## **FIELD SERVICE BULLETIN**

FSB Number: BJCCFSB2005-123  
Author: Jianfeng Ma  
Date: Apr 22, 2005  
Total No. Of Pages: 2  
Subject: **GSM Razr V3 Main Display Missing Line**  
Model Affected: GSM Razr V3  
Level of Repair: 1 & 2

Figure 1.0 – Missing Line

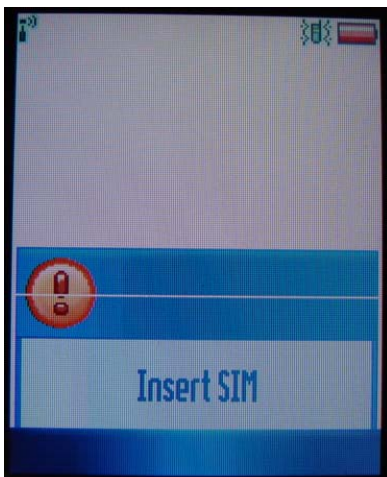
Service is aware of an issue identified during the 1st 200 NPI Analysis on V3. Some units, returned with a customer complaint of “Display Main,Missing Pixels / Icons”, were found to show one horizontal/vertical line on main display. Analysis revealed the failure was caused by excessive pressure in COG bonding process. The situation occurred due to pressure with foreign material between head of IC driver and press jig in the machine. Figure 1.0 below shows example of display with the missing line failure.

**Containment action:** The supplier Sanyo assembly factory changed the inspection interval of bonding place on microscope from 4 units / 15 minutes to 4 units / 10 minutes from December 10th, 2004. If the failure is found, all units produced for the period shall be checked with microscope. The period means the inspection interval that the failure unit was produced.

- a. Disassemble the Flip Assembly and verify that the failure is caused by the display module itself by replacing the suspect module with a known good module. Then replace the failed display module with a new one with date code 5xxx, reassemble the unit, and retest to confirm the repair.
- b. If the unit displays the original failure symptoms with the known good display module, then proceed with normal troubleshooting techniques as per the customer complaint.

Figure 2.0 – Date Code Identification

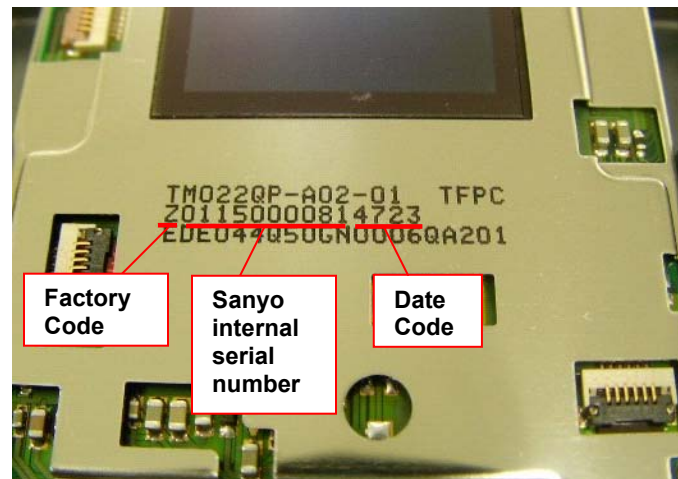
The supplier Sanyo increased the cleaning frequency against the jig to followings.  
Before change : Day shift 1 time, Night shift 1 time Total 2 times  
After change : Day shift 2 times, Night shift 2 times Total 4 times  
Implementation date: Dec. fourth week, 2004 (Date Code: 5xxx). See Figure 2.0 above.

**Date Code:** last 4 letters. Example: 4723 (4 – year; 7 – month; 23 – date )

**\*Affected Date Code: 4xxx (i.e. before 5xxx)**
